Response to Planning Comments

Summary of modifications to proposed scheme in response to planning comments

The following amendments are proposed in response to the comments received on 21.03.2025

Suggested updates to Proposed Scheme
(in response to planning comments)

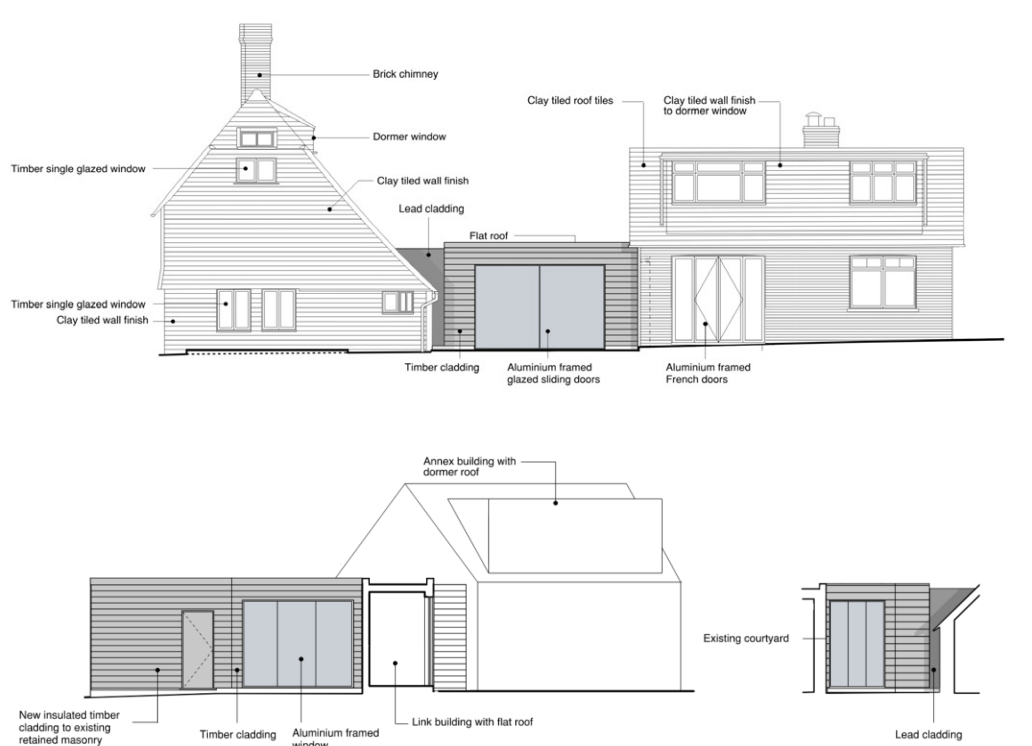
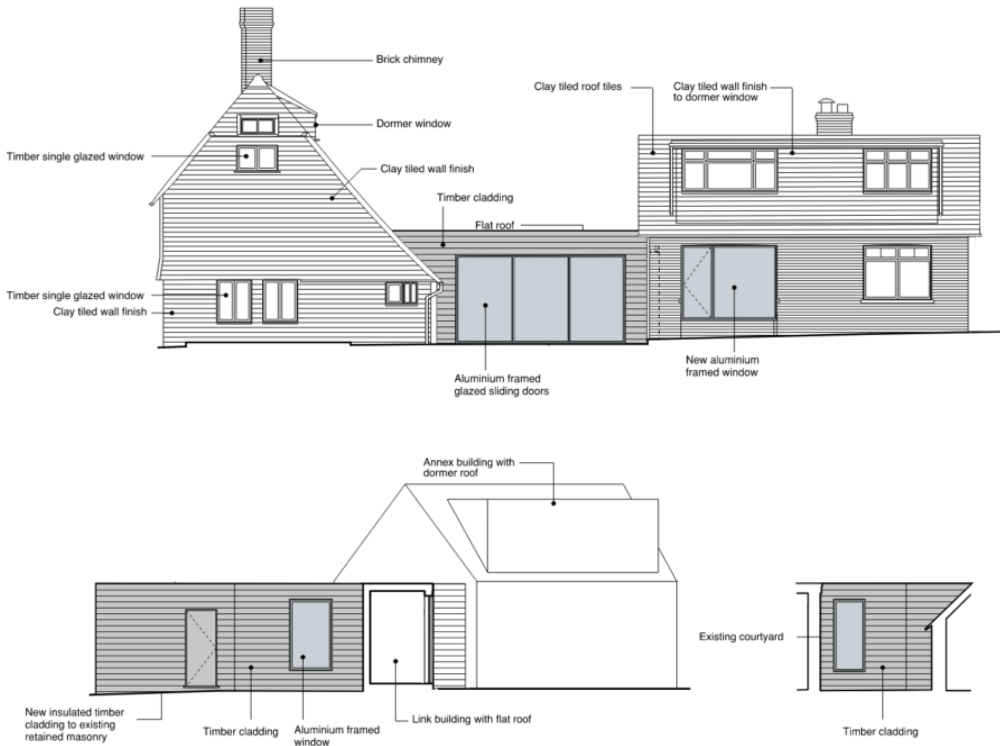
- 1. Modifications to the massing and materials at the junction between the link and the cottage. A step down along the parapet line allows the interface between the link and the cottage to remain as per the approved scheme without any further modifications to the catslide roof. This is reinforced by a subtle step inwards in plan at this location ensure the point of connection is a 'light-touch' as possible.
- 2. The step in mass allows for the introduction of lead roofing and cladding to provide a distinct visual separation between the mass of the link and the cottage. The use of lead is a traditinal material in-keeping with the historic listed context.
- 3. Significant increase in glazing to the courtyard facing kitchen extension elevation to reduce visual impact on courtyard and allow greater visibility and transparency through the link.

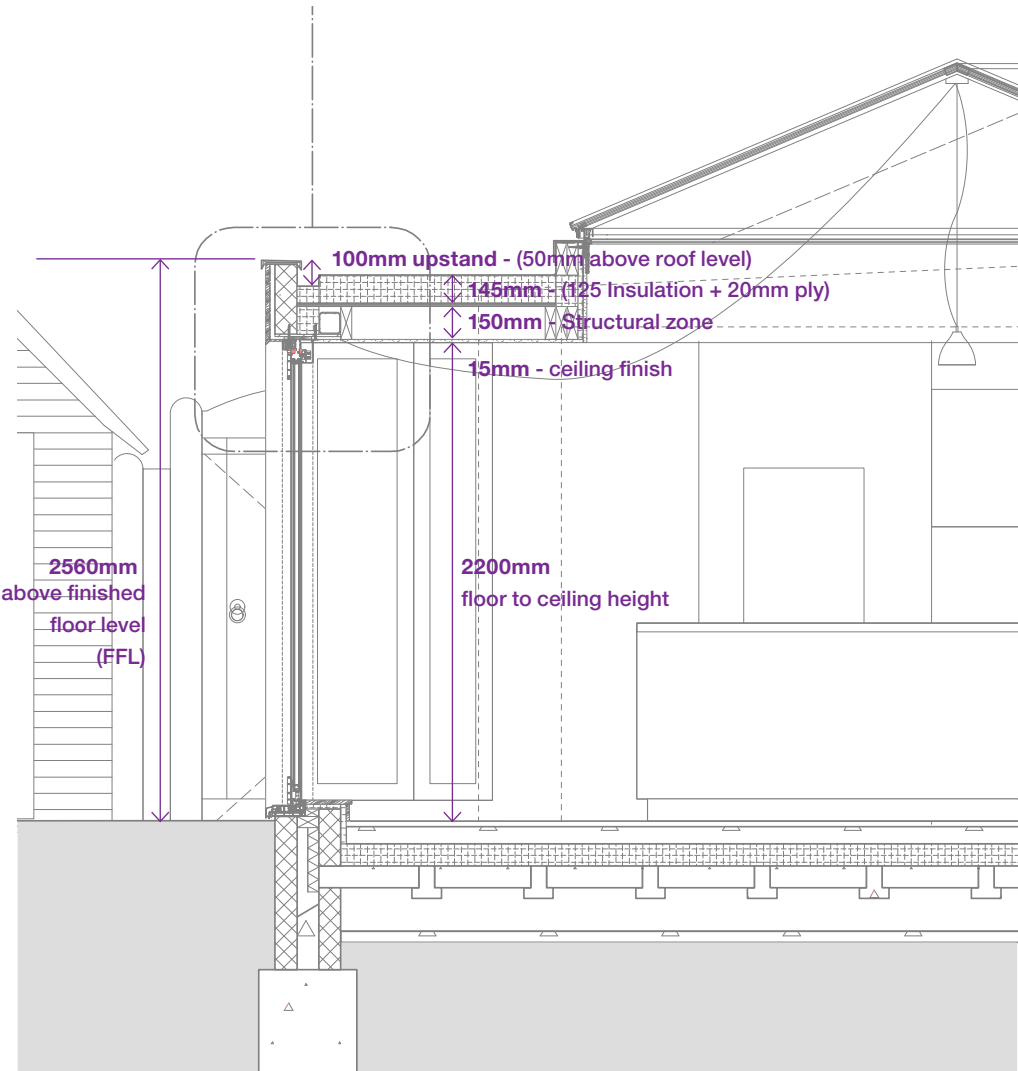
- The proposed changes to the form and footprint of the link extension remove the approved projection into the garden to the south of the house, so that the building line will be similar to the existing. This is not considered contentious in principle, however the height of the replacement link has increased so that it now sits above rather than below the eaves of the annexe building and rises higher up the catslide roof to the rear of the original building. This is not considered acceptable due to the adverse impact on the subservience of the link to the cottage and annexe, as well as the fabric of the catslide, and should be reconsidered. Furthermore proposed changes to the elevation to introduce more solidity will add to the apparent bulk of the link as well as reducing the extent to which it allows a visual separation between the house and the bulk of the annexe. The use of aluminium framed windows in place of timber framed also does not relate well to the context. I would also suggest that this should be reconsidered.

The height of the proposed parapet line for the replacement link has been based on the following factors:

1. The current link building is comprised of a series of roof sections with varying roof heights and parapet heights, which are illustrated in the photographs herein. The proposals seek to create a uniform roof and parapet height that is aligned to the existing parapet height along the north elevation of the link / kitchen. This will ensure a consistent parapet datum based on an existing condition. This alignment increases the height of the parapet marginally on the southern elevation compared to the approved proposals by circa. 1.5 brick courses (125mm).

2. The current floor to ceiling height within the sunroom is **2010mm** - only 10mm higher than minimum Building Regulations standards for stair landings. The generally accepted standards for habitable rooms within a residential dwelling is **2300mm**.

The approved application achieves 2200mm floor to ceiling height by raising the roof level + dropping the existing floor level of the sunroom to match the existing kitchen floor level.

The Proposed application seeks to achieve the same 2200mm floor as the approved scheme. However, the approved roof detail / build-up is not considered achievable based on structural input and current building regulations requirements (June 2022).

i) Structural zone - Approved scheme is allowing 150mm zone for structure. This is considered inadequate to achieve the clear spans required. It is proposed to increase this zone to 200mm for appropriate structural depths for steel beams and timber joists.

ii) Thermal insulation zone - Approved scheme is only showing 125mm insulation and roofing membrane zone. The proposals suggest this needs to increase to 150mm min. to achieve Building Regulations U-Value requirements for roofing elements.

iii) Parapet height - The approved scheme shows a concealed gutter detail created by a step in the insulation around the perimeter of the roof. This creates a upstand height of 100mm at the edge. The proposals seek to increase this upstand height to 150mm to align with best practice.

The table on the right illustrates the dimensions of the external wall build-up of the approved scheme and the proposed build-ups based on the commentary above. The proposed scheme seeks to increase the roofline of the link renovation by 125mm compared to the approved scheme.

Approved Scheme

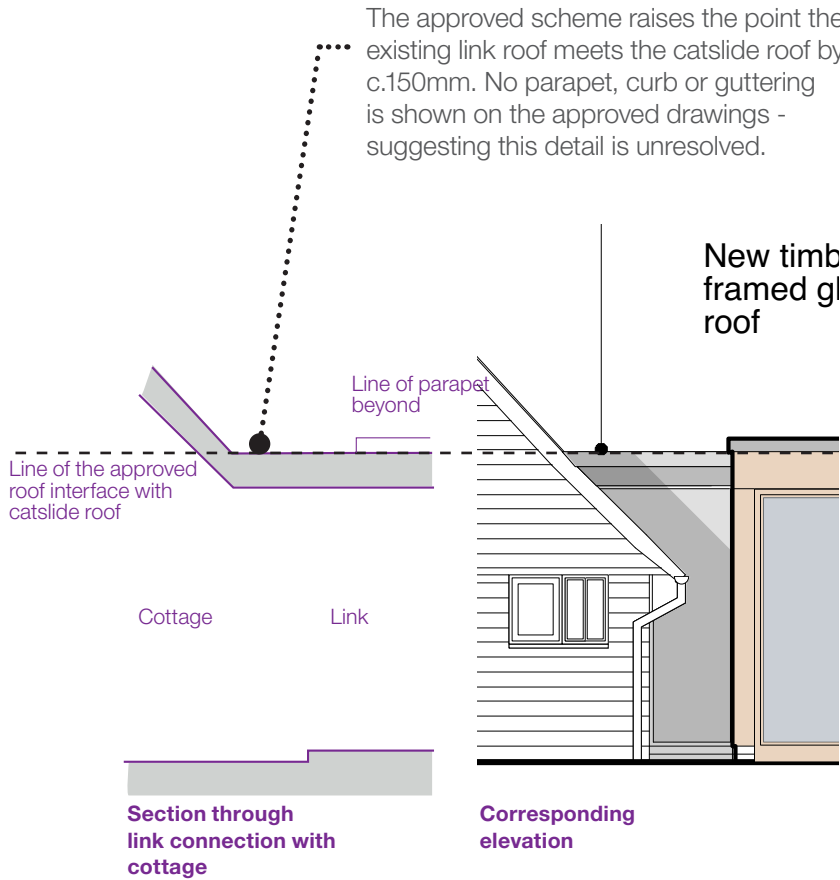
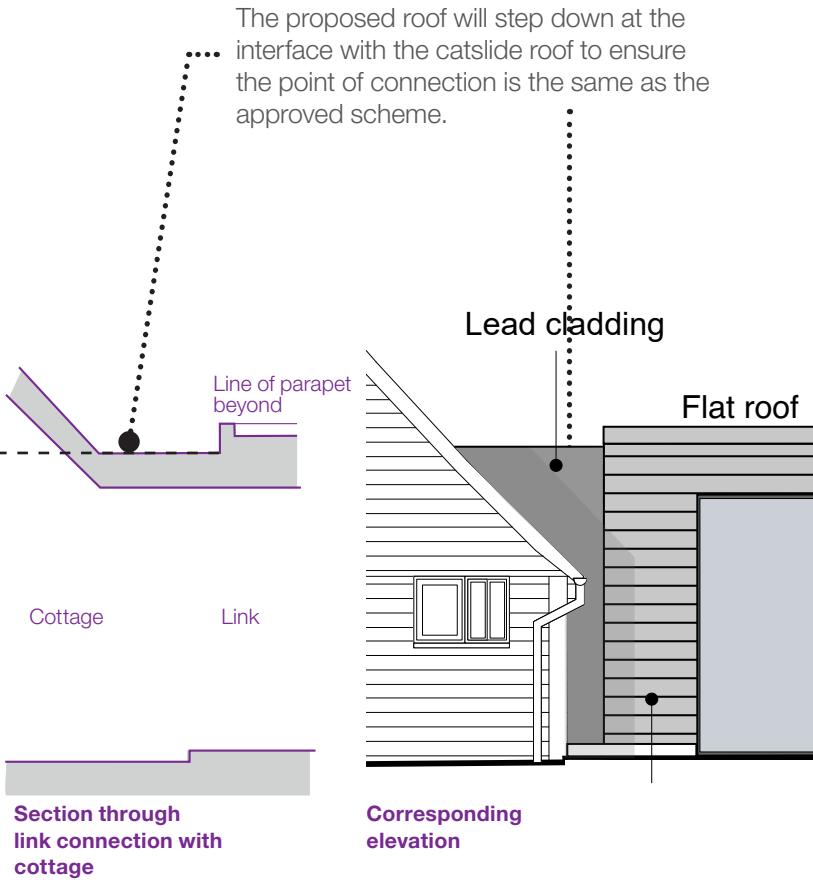
In response to the planning comments associated with the catslide roof we have modified the proposed scheme to include a step at the point of connection between the link and the cottage - similar to the approved scheme.

It is proposed that the point of connection between the link roof and the catslide roof **will be the same as the approved scheme**.

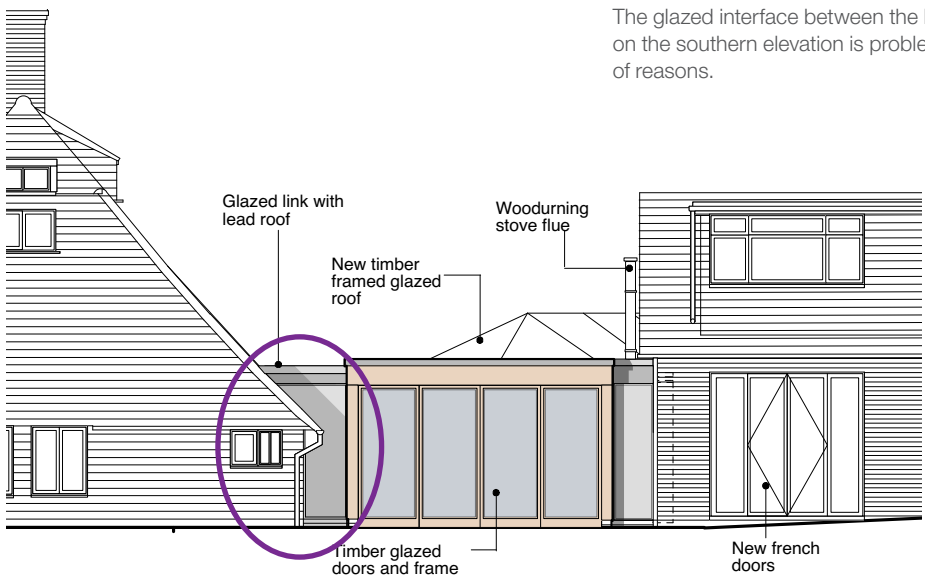
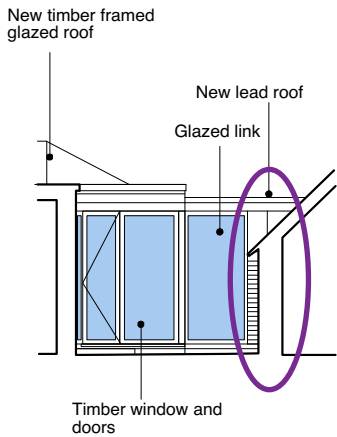
- The proposed changes to the form and footprint of the link extension remove the approved projection into the garden to the south of the house, so that the building line will be similar to the existing. This is not considered contentious in principle, however the height of the replacement link has increased so that it now sits above rather than below the eaves of the annexe building and rises higher up the catslide roof to the rear of the original building. This is not considered acceptable due to the adverse impact on the subservience of the link to the cottage and annexe, as well as the fabric of the catslide, and should be reconsidered. Furthermore proposed changes to the elevation to introduce more solidity will add to the apparent bulk of the link as well as reducing the extent to which it allows a visual separation between the house and the bulk of the annexe. The use of aluminium framed windows in place of timber framed also does not relate well to the context. I would also suggest that this should be reconsidered.

- For similar reasons to those given above the proposed amendments to the external wall of the kitchen extension are in my opinion contentious. One of the reasons why this extension was considered acceptable in the context of the existing additions to the building was the lightweight and transparent treatment of this elevation, which reduced the apparent bulk of the addition and mitigated the manner in which it imposes on the existing courtyard space. I would therefore recommend that this aspect of the proposal is also reconsidered.

The approved scheme shows an almost entirely glazed southern elevation and interface with the cottage. This is problematic for a number of reasons:

- i) The extent of south facing glazing, coupled with the large roof lantern will be susceptible to significant overheating in the summer months. This extent of glazing far exceeds the 2022 Approved Document Part O guidance. The Proposed alterations seek to introduce significantly more glazing than the existing condition, but in a way that balances visibility and ‘lightness’ with appropriate levels of thermal comfort.
- ii) The glazed interface with the cottage is unlikely to be feasible as shown in the approved drawings. As illustrated in the photograph of the existing condition, the interface is extremely complicated, with projecting eaves, gutters and the need to abut with both a stone wall condition and a catslide tiled roof condition.

The glazing panel would need to be manufactured to accommodate this complicated profile and the frame would need to be suitably thick to allow an appropriate flashing detail between the roof and the glazing. This would create much bigger framing profiles and sightlines than shown, and would create an extremely vulnerable detail that would be susceptible to failure and future weather damage to the cottage.

iii) The approved drawings show a flat lead roof at the interface with the cottage. This would mean all the rainwater will run-off the sides of the roof and down the face of the glazing. To avoid this, a gutter and downpipes will be necessary to deal with this roofing condition which will further impact the visual ‘cleanliness’ of what has been drawn.

iii) The courtyard facing elevation of this link interface avoids this glazed detail, and instead shows a solid wall at the point connection between the link and the cottage. This is considered a more appropriate interface detail. The proposed scheme seeks to replicate this approved detail on both sides of the link.

The glazed interface between the link and the cottage on the southern elevation is problematic for a number of reasons.

The approved scheme shows a solid wall interface detail between the link and the cottage. The proposed scheme seeks to replicate this approved detail on both sides of the link for a more appropriate and robust detail

Suggested updates to Proposed Scheme
(in response to planning comments)

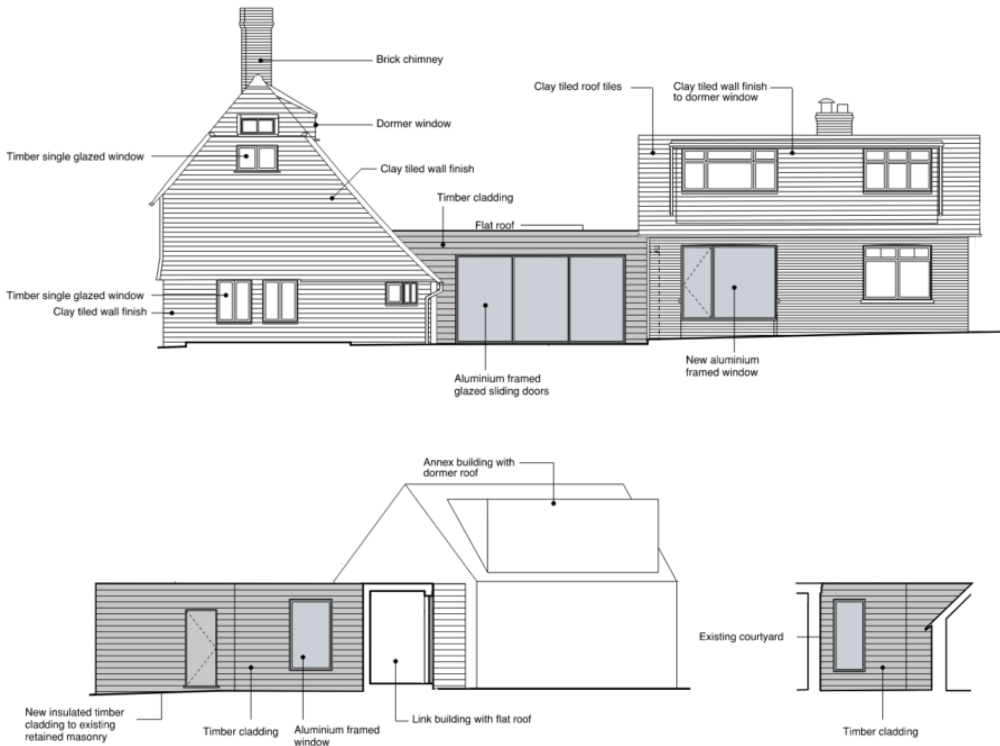
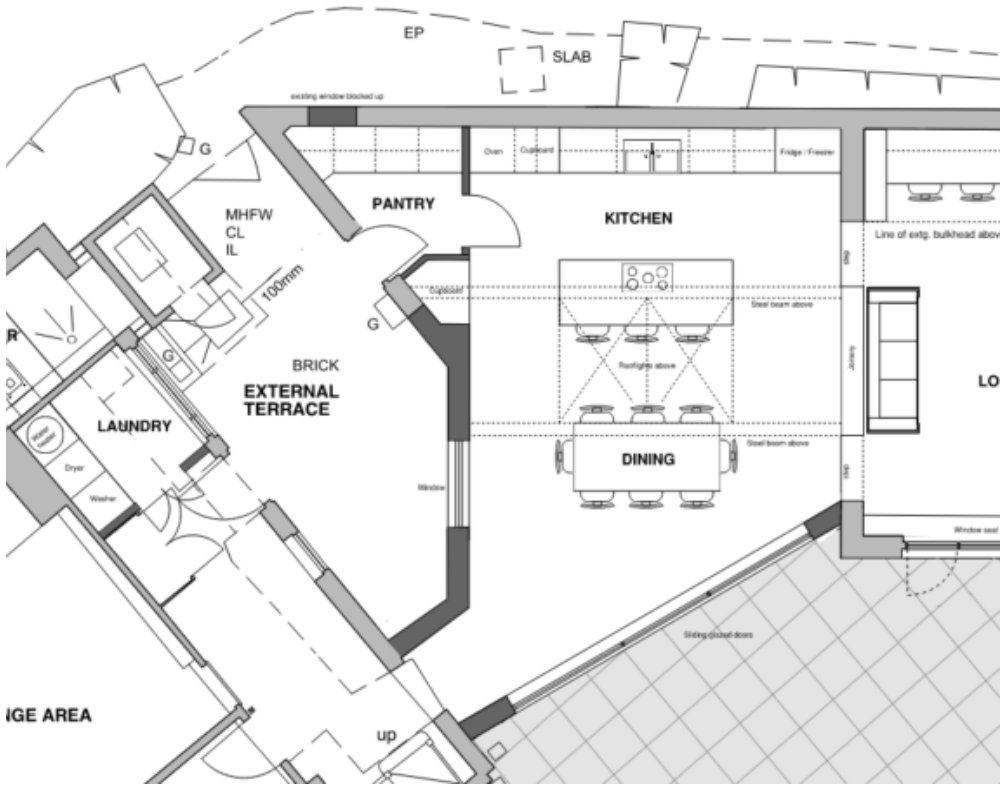
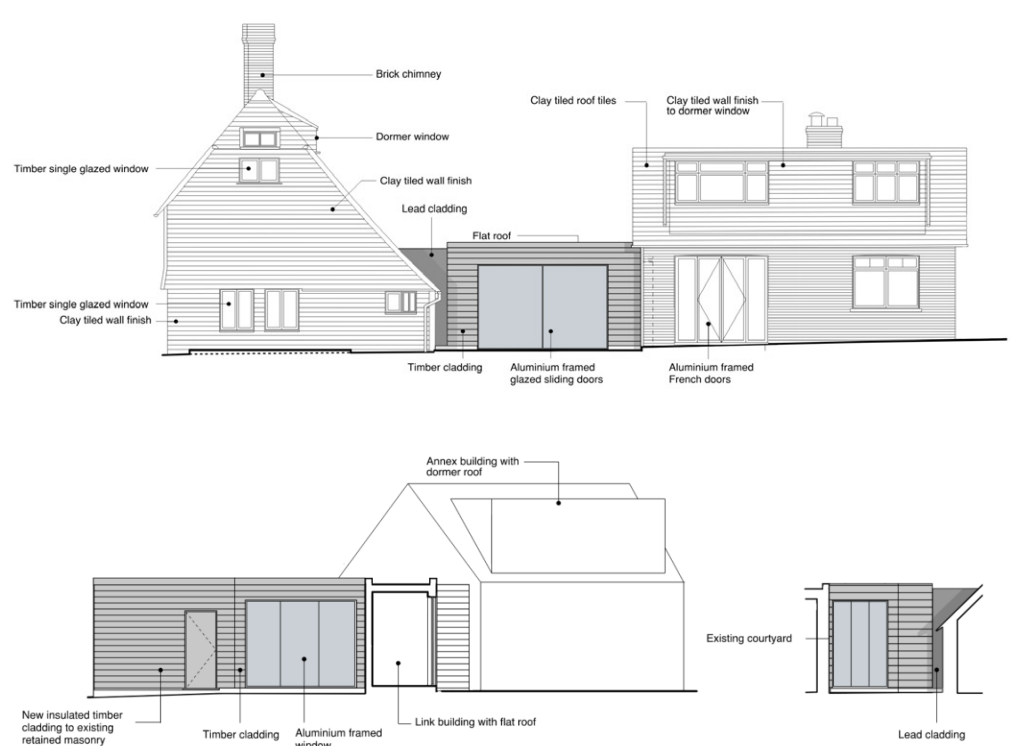
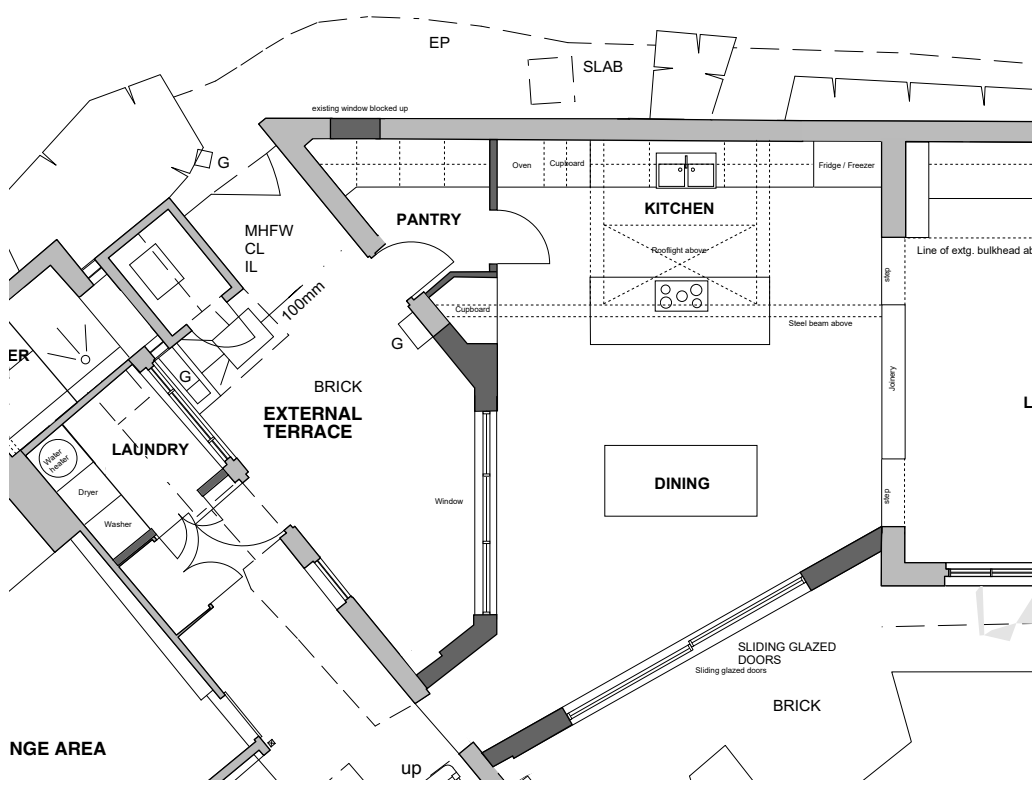
The following amendments are proposed in response to the comments associated with the extent of glazing:

Extent of glazing to the west (courtyard facing) elevation of the kitchen extension has been increased significantly in response to the planning comments and the desire for a more transparent and less imposing treatment.

Modification to glazing to south elevation to accommodate alterations to the link interface with cottage and to allow for appropriate zone for structure (which was not shown / accommodated in the approved scheme).

Glazing extent now meets Approved Document Part O guidance.

Total linear length of glazing increased from previous proposal.

The proposed modifications to the previously approved french doors have been removed from this application.
